Office Action Summary

10/757,776

BOEHM ET AL.

DETAILED ACTION

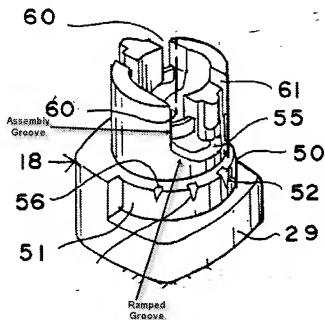
Abulhaj discloses a lancet with an adjustable depth mechanism in which a cap (18) is adjustable by a pin/groove mechanism (Fig. 15-16 where the pin (31) enters the groove seen in the figure below) where the groove has an assembly groove (see figure below) extending in a first direction (it extends longitudinally from the proximal end towards the distal end) and a ramped groove (see figure below) extending in a second

direction (it extends diagonally as seen in the figure below) deviating from the first direction (see figure below).

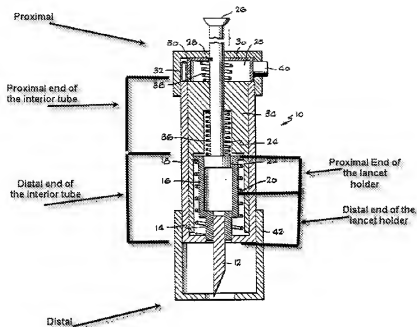
Hofert discloses a rearward body assembly of a lancing device that can propel a lancet (12) into a lancing surface, the rearward body assembly comprising: a lancet holder (16) comprising one or more retaining features (14) and one or more spring surfaces (the outer area and the top surfaces of the lancet holder are spring surfaces since the surface is in contact with the springs) at the distal end (see figure below where the distal end is labeled) and one or more lancet holding features (the internal wall of 14 and 16 as seen in the Figure) at the proximal end (the proximal portion of the holding features is at the proximal end as defined in the figure below); an interior tube (34) comprising an open end (proximal end as seen in the Figure) and a slotted end (distal end where it is stepped and has an opening as seen in the Figure) through which the

one or more retaining features extend (see the Figure where it extends out when the lancet holder is propelled out), the interior tube (34) being adapted to slidably engage the lancet holder (16) (the lancet holder is placed inside the inner tube as seen in the Figure); a finger cover (18) (note that the finger cover according to applicant's drawings is a collar that goes over the interior tube as best seen in Fig. 3 of the current application) arranged along a periphery of the interior tube (see Figure); an internal compression spring (36) comprising a first end and a second end (see Figure), the first end of the internal compression spring (36) being adapted to act on the slotted end of the interior tube (34) (the proximal end of the spring is in contact with the slotted area as seen in the Figure) and the second end of the internal compression spring (36) being adapted to act on the one or more spring surfaces of the lancet holder (16) (the distal end is in contact with the lancet holder so when a force is applied on the spring it will act on the spring surfaces); a retainer (42) comprising a slotted surface (opening where the finger collar enters) at the distal end of the interior tube (see figure below) through which the one or more retaining features extend (see the Figure where it extends out when the lancet holder is propelled out); a rearward body (combination of 24 and 22), the rearward body engaging the retainer (it is indirectly engaged to the retainer); wherein longitudinal movement of the rearward body away from the interior tube compresses the interior compression spring (36) (by pulling on the rearward body it can compress the interior tube) (Col. 3 Lines 5-10) and an external compression spring (20) comprising a first end and a second end (see the Figure), the first end comprising a reduced coil diameter that engages the one or more retaining features (14) of the lancet holder (16)

as seen in the Figure, the first end of the external compression spring being adapted to act on the lancet holder (the spring is holding the lancet holder which will act on it to cause the deployment of the lancet) and the second end of the external compression spring being adapted to act on the slotted surface of the retainer (the spring is compressing on the retainer therefore it is acting on the slotted surface); and wherein the one or more spring surfaces of the lancet holder engages both the internal compression spring and the external compression spring (see Figure where the one or more spring surfaces engages indirectly to both spring).
